**Reference: Permit to Operate Application Response to NCDENR Items**  
Retired Ash Basin (RAB) – Ash Landfill  
Duke Energy - Allen Steam Station, Belmont, NC  
S&ME Project No. 1356-06-825, NC PE Firm License No. F-0176

On behalf of Duke Energy, S&ME, Inc. (S&ME) prepared this letter and related information in support of the Permit to Operate Application for Cell 1 of the Retired Ash Basin (RAB) Ash Landfill at Duke Energy's Allen Steam Station. Specifically, this letter provides responses to North Carolina Department of Environment and Natural Resources (NCDENR) comments listed in an email received by Duke Energy and S&ME on Tuesday, September 15, 2009. The items are summarized in this letter (in italics) along with S&ME's responses to those items.

OPERATIONS PLAN  
RETIRED ASH BASIN (RAB) - ASH LANDFILL  
ALLEN STEAM STATION  
BELMONT, NORTH CAROLINA  
**S&ME Project No. 1356-06-825**

FIGURE NO. **1**

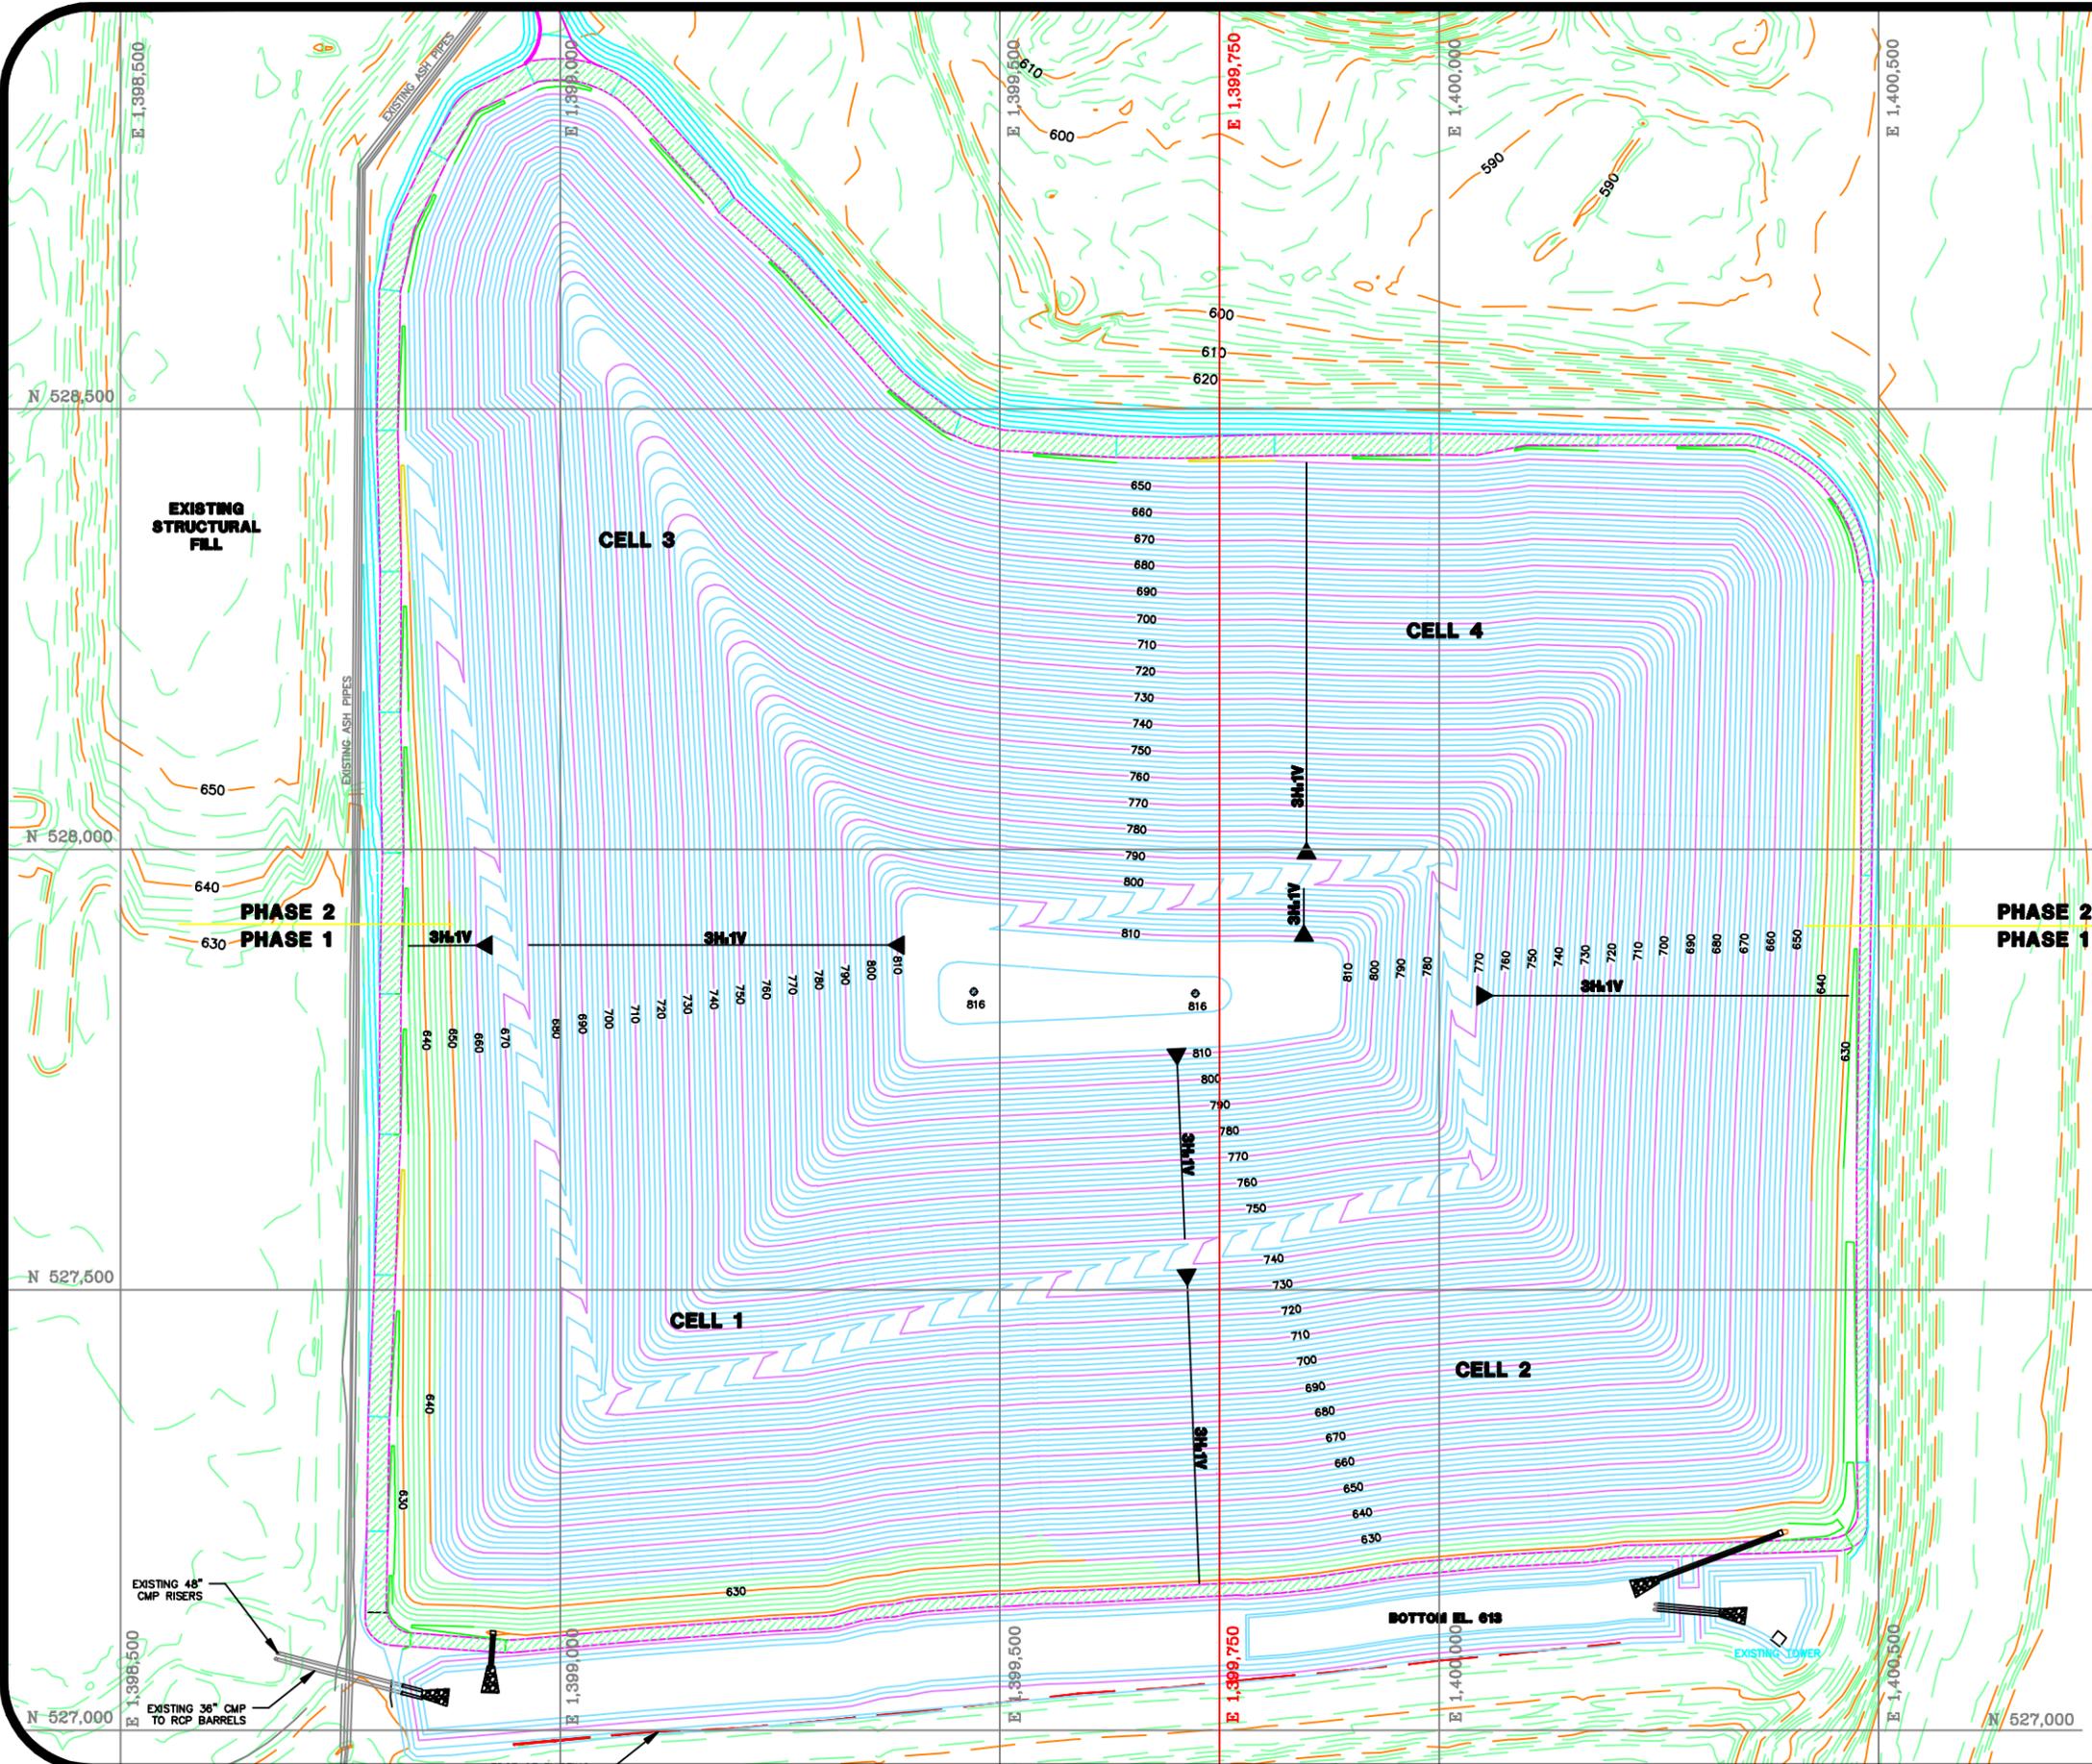
*Item 6: Figures 1, 2, 3, and 5: Label all slopes and indicate maximum slope allowable (see comment 3 above).*

Response 6: Operations Plan Figures 1, 2, 3, and 5 have been revised to label slopes and to include a note stating "MAXIMUM SLOPE ALLOWABLE IS 3 (HORIZONTAL) TO 1 (VERTICAL)."

FIGURE NO.  
**3**

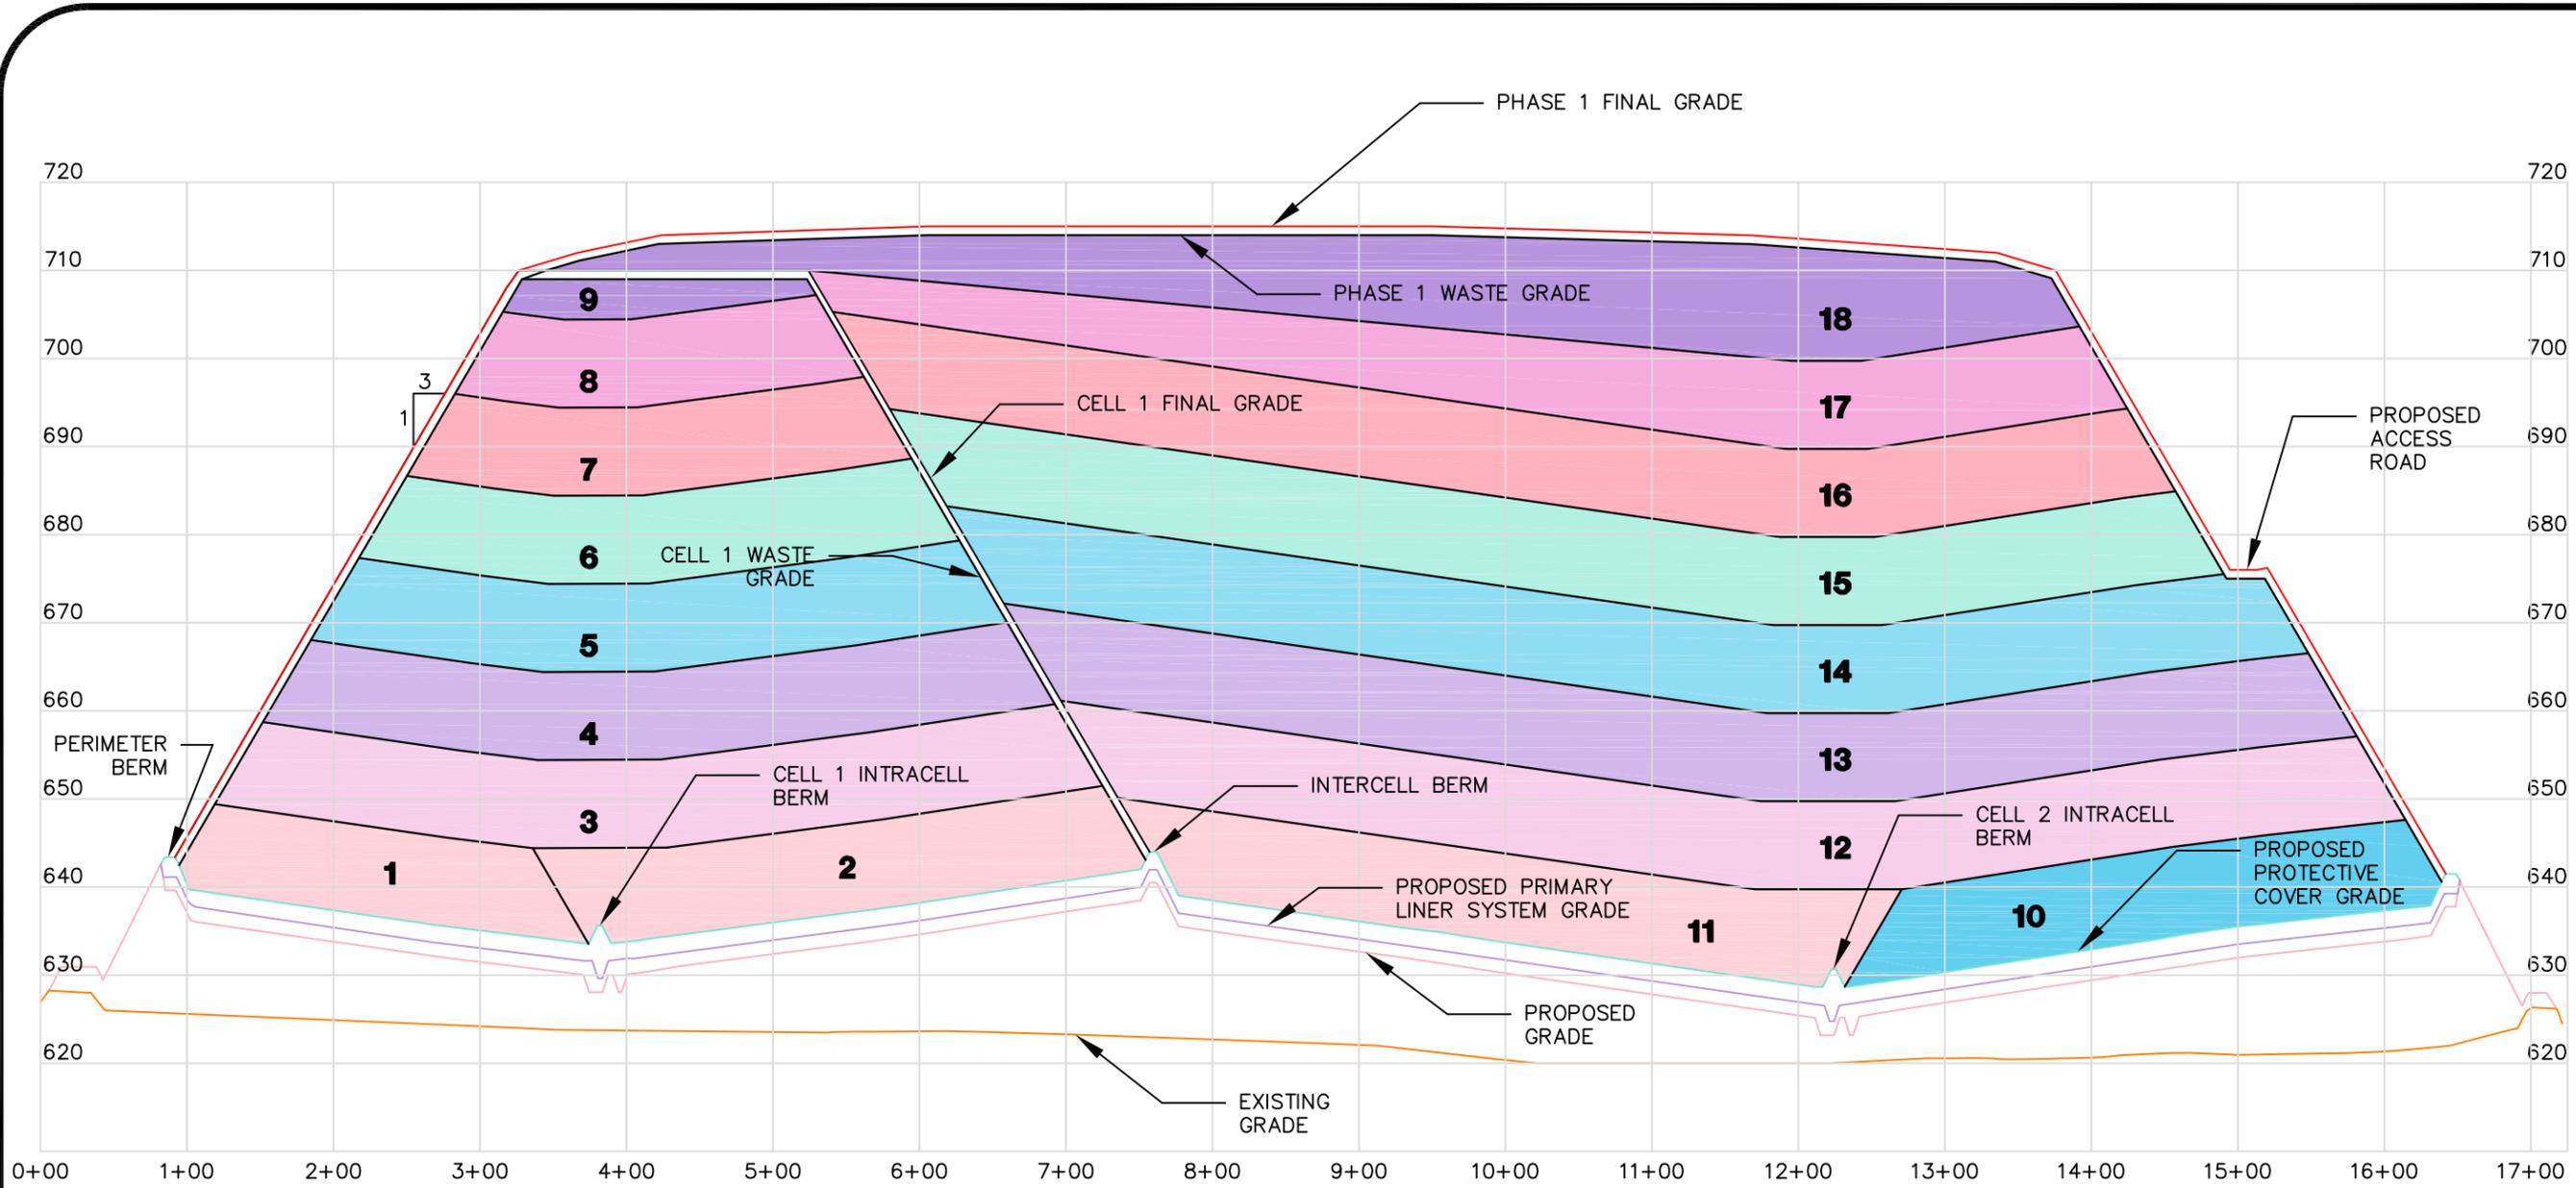
Item 3: *Section 2: Provide a section for “General Grading” stating that the contractor shall follow lines and grades shown on the construction drawings (or figure/exhibit) with slopes no flatter than 3 (horizontal) to 1 (vertical).*

Response 3: The following statement has been included in Section 2.5 of the Operations Plan: “Waste and cover material shall be placed to the lines and grades shown on the grading plans with slopes no steeper than 3 (horizontal) to 1 (vertical).” The Cell 1 grading plan is provided in the Operations Plan Figure 3. The Phase I grading plan is provided in Operations Plan Figure 5.

**Global Slope Stability Analysis (EW LtoR Static Deep Failure)**  
 Allen Steam Station  
 253 Plant Allen Rd.  
 BELMONT, NORTH CAROLINA

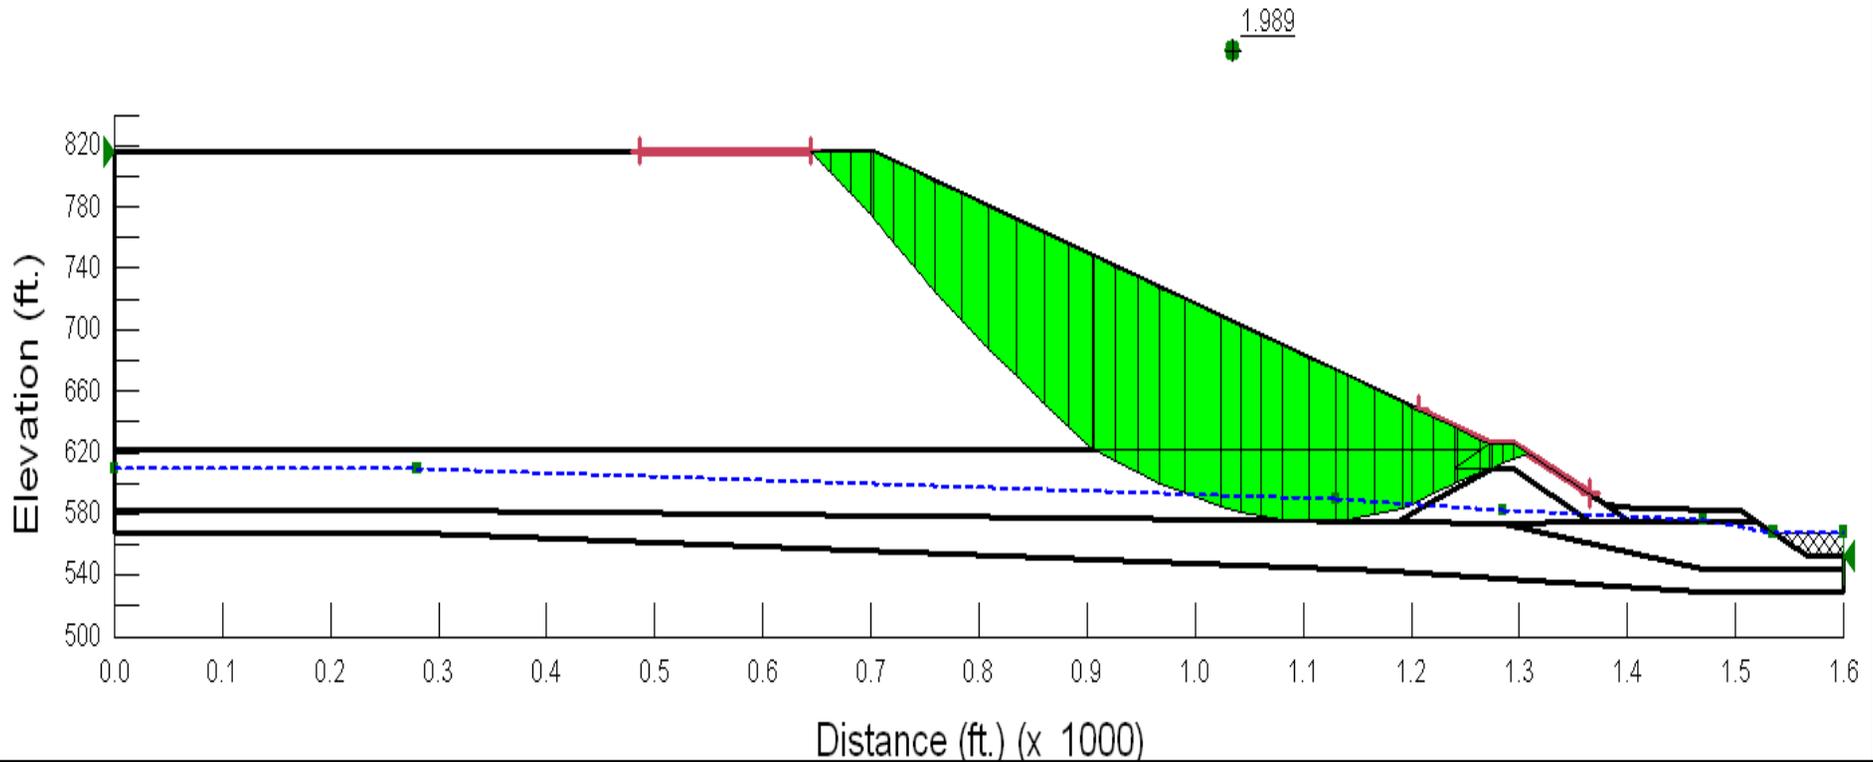
Item 4: *Section 2.5-2: One in-place density test per 8,000 CY of placement at 12-inch loose lifts as specified would roughly equate to 72,000 square feet of surface area. In-place density testing frequency should be based on quantity of material placed in units as defined by the construction contract or in square feet of lift with specified thickness (12 inches in the case). One in-place density test per 20,000 square feet of lift is recommended. An existing conditions baseline survey will be required.*

We also understand that the primary area of concern is the east side of the landfill, adjacent to the Catawba River. Results of slope stability analyses reported in the Permit to Construct Application indicate a potential circular failure surface from the top of the slope to the toe of the slope (reference attached Figure 5 from the Permit to Construct Application Global Slope Stability Calculation). Based on this observation, we propose conducting density tests in the area of primary concern, namely the area between Easting 1,399,750 and the east landfill perimeter as shown in Operations Plan Figures 1, 2, 3, and 5.

We believe that an in-place waste density of 95 percent of the standard Proctor maximum dry density is adequate to achieve field performance consistent with the slope stability
